R09PD

**SUBJECT: RECALL R09PD INCORRECT BOLTS AND/OR SPACER IN
ENGINE COOLING FAN**

MODELS AFFECTED: 2008-2009 BBCV Visions w/ 2007 Cat Engines

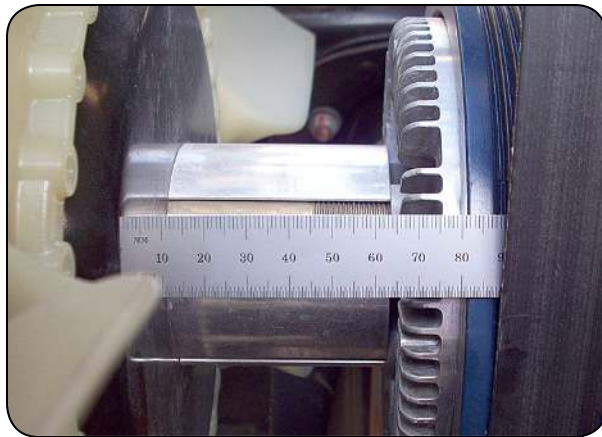
Fan may separate from fan clutch and may damage fans blades, fan clutch, radiator, hoses and other surrounding components.

Inspect fan spacer length and install new spacer and bolts as required.

Inspection

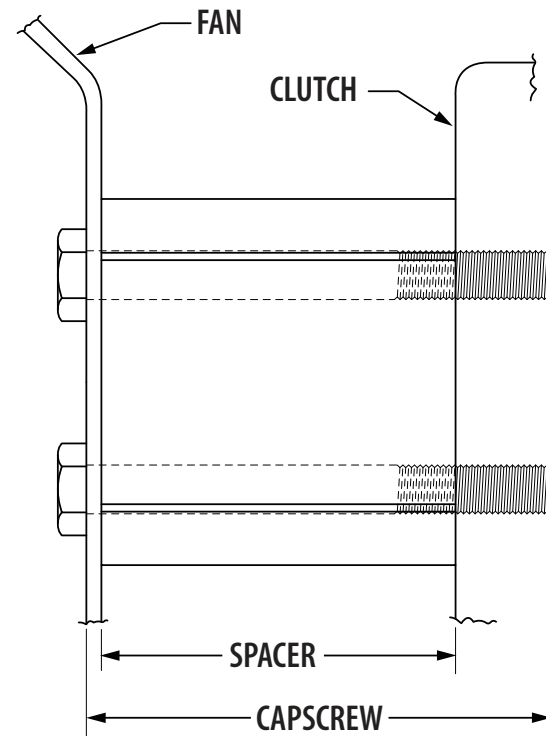
- 1 Park vehicle on a level surface, apply parking brake, turn engine off, remove ignition key and chock wheels.
- 2 Disconnect batteries.
- 3 Open engine hood.
- 4 Measure the length of the spacer between the fan blade and the fan clutch. See Diagram and Chart to the right for correct installations and determine procedure needed.

PROCEDURE 2 (with wrong spacer and wrong capscrews)
For CAT C707 with CGI & DPF, and a 52.8mm (2 5/64 inch) spacer.
Note: Caterpillar C707 with CGI and DPF has a Regen switch mounted on the entrance door side fire wall.

PROCEDURE 3 (with wrong spacer and wrong capscrews)
For CAT C7 without CGI & DPF, or Export unit; with a 66.7mm (2 5/8 inch) spacer.

PROCEDURE 1 (with correct spacer and wrong capscrews)
For CAT C707 with CGI & DPF, and a 66.7mm (2 5/8 inch) spacer.
Note: Caterpillar C707 with CGI and DPF has a Regen switch mounted on the entrance door side fire wall.

ENGINE	SPACER	CAPSCREW
CAT C707 with CGI & DPF	66.7mm (2 5/8 inches)	90mm M10-1.5 X 90mm
CAT C7 or Export without CGI & DPF	52.8mm (2 5/64 inches)	70mm M10-1.5 X 70mm
